GOLF CART GEEKS

1140/1141_12 and 36 Volt Solenoid

G1 Gas/Electric Solenoid Replacement

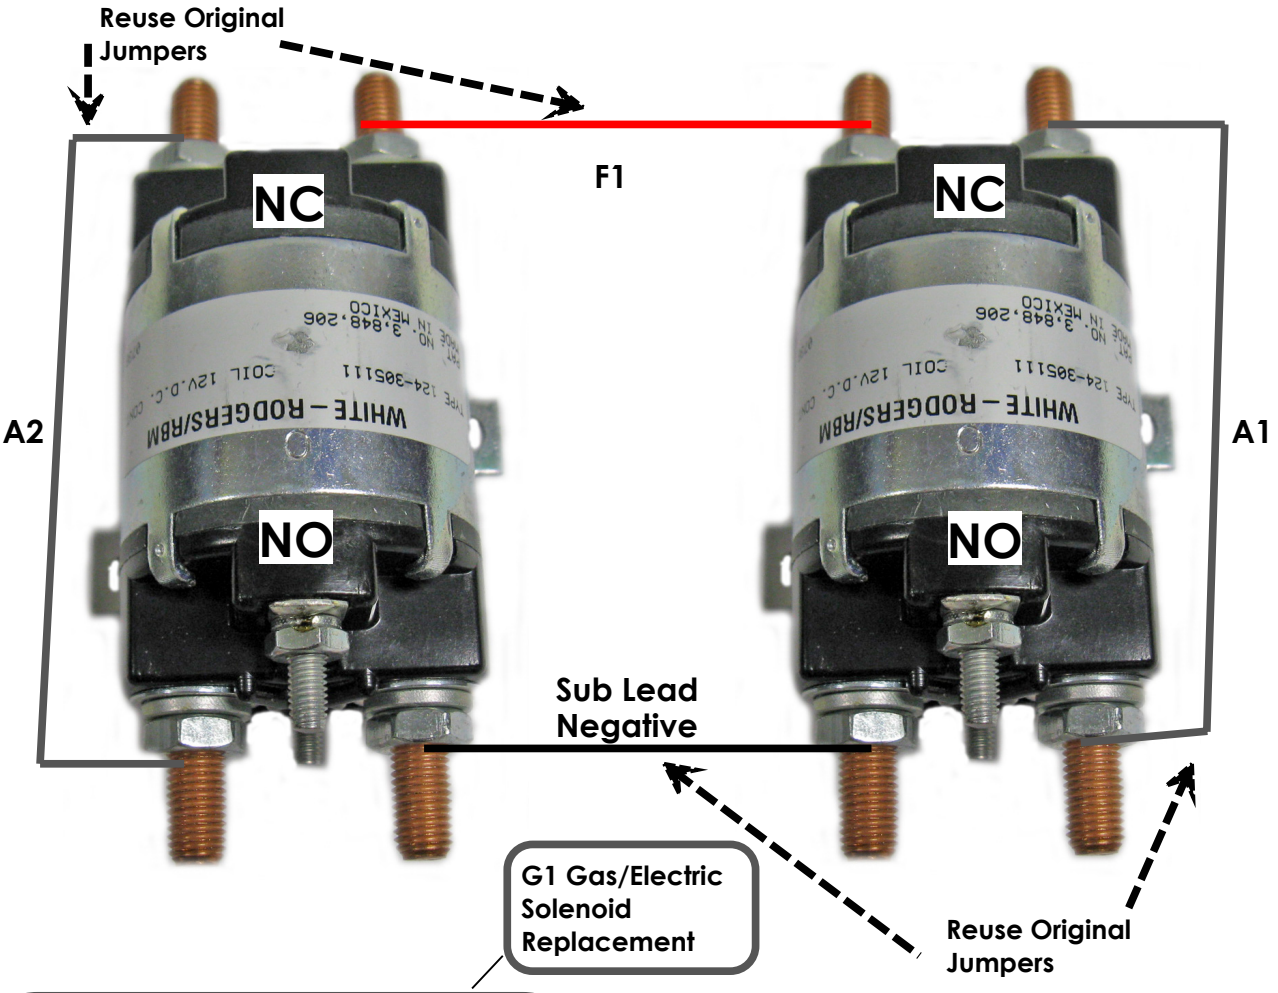
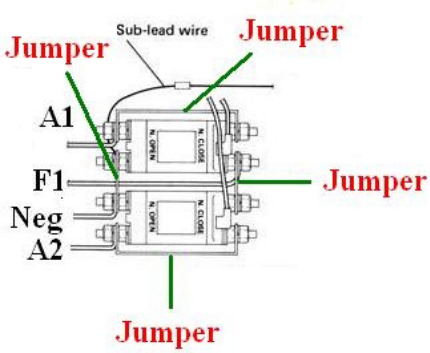
The O.E.M. solenoid contacts are opposite to the new replacement. The old style has normally open (NO) contacts on the two pole end. The four pole end is normally closed (NC).
The replacement solenoid is NO on the four pole end and NC on the two pole end.

Electric Carts:
A1 is F1 and A2 is F2. Battery positive connects to NO end and the resistor lead cable connects to the NC end. The battery charging lead wire connects to positive at NO.

Gas Cars:
F1 cable connects to NC end of solenoid.
Battery negative cable connects to NO end of solenoid with the Sub Lead wire.
